# Inspection Report

Permit Number:	C0150009
Inspection Type:	COMPLETE OVERSITE
Inspection Date:	Tuesday, March 08, 2016
Start Date/Time:	3/8/2016 9:00:00 AM
End Date/Time:	3/8/2016
Last Inspection:

Permittee: **FOSSIL ROCK RESOURCES, LLC**  
 Operator: **FOSSIL ROCK RESOURCES, LLC**  
 Site: **FOSSIL ROCK MINE**  
 Address: **225 North 5th Street, 9th Floor, CO 81501**  
 County: **EMERY**  
 Permit Type: **PERMANENT COAL PROGRAM**  
 Permit Status: **INACTIVE**

**FIGURE 1**

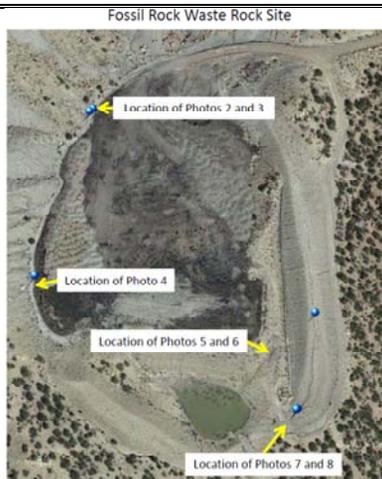
NOV #21172 is issued requiring the Permittee to address three non-compliance issues with Diversions at the waste rock site. Drainage at the waste rock site does not match the designs or narrative in the MRP for Ditch DA, Ditch DB, and the ASCA at the southern end of the Subsoil Pile. Attachment A provides photos showing the condition of the ditches and the ASCA with Figure 1 identifying the photo locations at the waste rock site. The three non-compliance issues are as follows:

1. Ditch DA: Photos 2, 3, and 4 show the condition of Ditch DA. It is not maintained to function as a V-ditch with 2.5:1 side slopes as outlined in the MRP. In its current state the ditch is box cut with nearly vertical side slopes and a flat ~2 ft wide bottom. As stated in Volume 4, Appendix C, 'Drainage Control Design' for Ditch DA (see attached highlighted text from the MRP), "Ditch DA will be a V-ditch for the entire length until it approaches the pond where the slope increases from 2 to 18%". A cross-section of 'Ditch DA DETAIL 1' for this upper section is shown on Drawing 4-14 (CM-10877-WB), titled 'Interim Surface Refuse Drainage Plan'.

2. Ditch DB: Photos 5 and 6 show Ditch DB has not been maintained as designed in Volume 4, Appendix C, 'Drainage Control Design' stating, "Ditch DB will be a narrow trapezoidal ditch for its entire length". The ditch design calls for a, "2 foot bottom width, [and] 2:1 side slopes". Photo 6 shows Ditch DB is non-existent through this section and an access road has been constructed in its place. This disruption has prevented runoff from being properly routed to the sediment pond.

3. ASCA, southern end of Subsoil Stock Pile: Photo 8 shows there is no clear runoff flow path on the southern end of the Subsoil Stock Pile that directs water to the silt fence in Photo 7. The silt fence in Photo 7 needs to be properly maintained.
